Access Compliance Report

Public Rights-of-Way

Intersection ID: 30343	Main Street: SANDBOAR_ST	Cross Street: WADING_LN	Location: SE
ADA ID: 9B3B98574D5F	Ramp Type: PerpDiag	Initial Pass/Fail: Fail	Overall Compliance: No
		Severity Score: 10

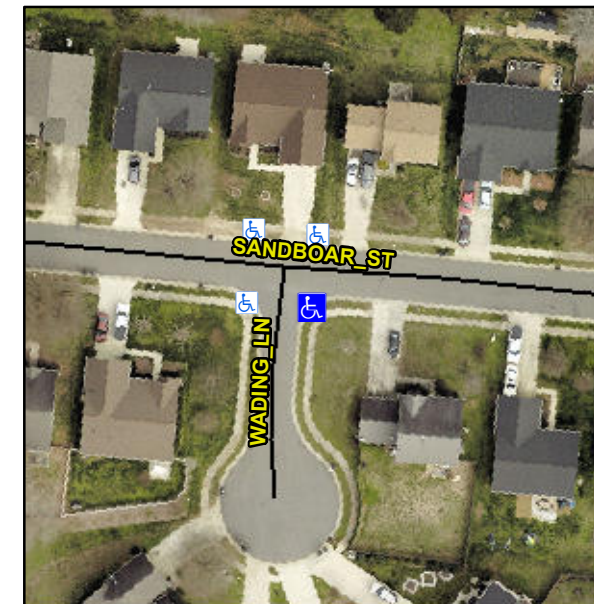
Not Found, R304.5.1, R304.5.3

Compliance	Description	Data	Compliance	Description	Data
N/A	Ramp Length (in)	48.5	Yes	Ramp Slope (%)	5.4
No	Ramp Width (in)	45.5	No	Ramp XSlope (%)	2.7
N/A	Flare Type LT	N/A	N/A	Flare Type RT	N/A
N/A	Flare Slope LT (%)	N/A	N/A	Flare Slope RT (%)	N/A
N/A	Flare Traversable LT?	N/A	N/A	Flare Traversable RT?	N/A
N/A	Landing Length (in)	N/A	N/A	DWS Provided?	N/A
N/A	Landing Width (in)	N/A	N/A	DWS Contrast?	N/A
N/A	Landing Slope (%)	N/A	N/A	DWS Length (in)	N/A
N/A	Landing X Slope (%)	N/A	N/A	DWS Full Width?	N/A
N/A	Landing Curb? (Y/N)	N/A	N/A	DWS Offset (in)	N/A
N/A	Shared Landing?	N/A			
N/A	Gutter Ponding?	N/A	N/A	Gutter Slope (%)	N/A
N/A	Gutter Lip Ht (in)	N/A	N/A	Gutter X Slope (%)	N/A
N/A	Painted X Walk1?	No	N/A	Painted X Walk2?	No
	X Walk 1 Direction	To N		X Walk 2 Direction	To W
N/A	X Walk 1 Width (in)	N/A	N/A	X Walk 2 Width (in)	N/A
	X Walk 1 Slope (%)	3.4		X Walk 2 Slope (%)	5.5
	X Walk 1 X Slope (%)	3.3		X Walk 2 X Slope (%)	2.2

Remove & Replace Curb Ramp With Two New Directional Ramps or Equivalent.
